Applicant acknowledges the Examiner's statement regarding the patentability of generic independent claims in general. However, Applicant respectfully requests examination of this application on the merits including independent claim 1, which is generic to the species identified in the prior restriction requirement.

1. A heating and air conditioning installation for a vehicle comprising:

Fig. 6a

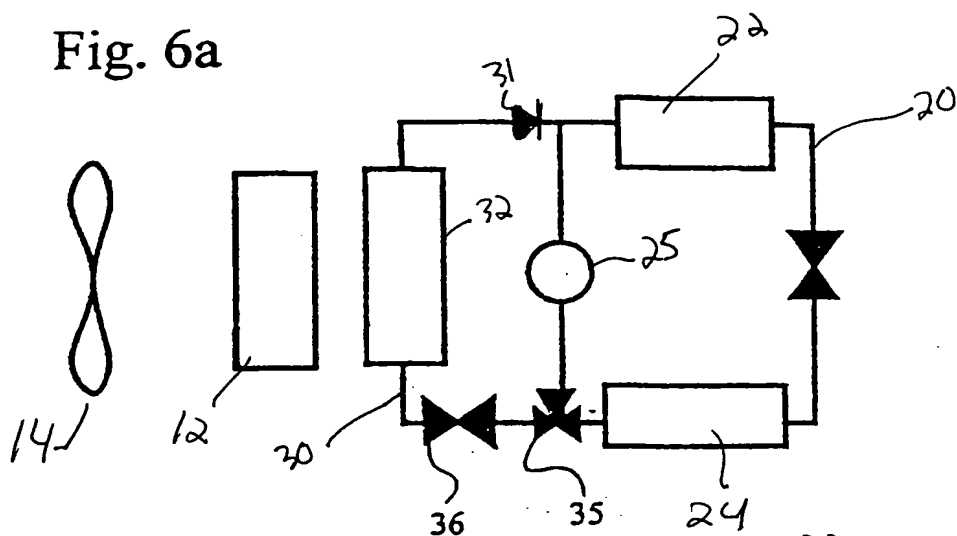
The Examiner has objected to the drawings 6A-6E and 7, as submitted on July 15, 2002 because some of the figures remain unnumbered. Applicant includes herewith proposed drawings 6A-6E and 7 adding the missing reference numerals marked in red-ink. Accordingly, Applicant respectfully request entry of the proposed drawings and withdrawal of the Examiner's objection to drawings 6A-6E and 7.
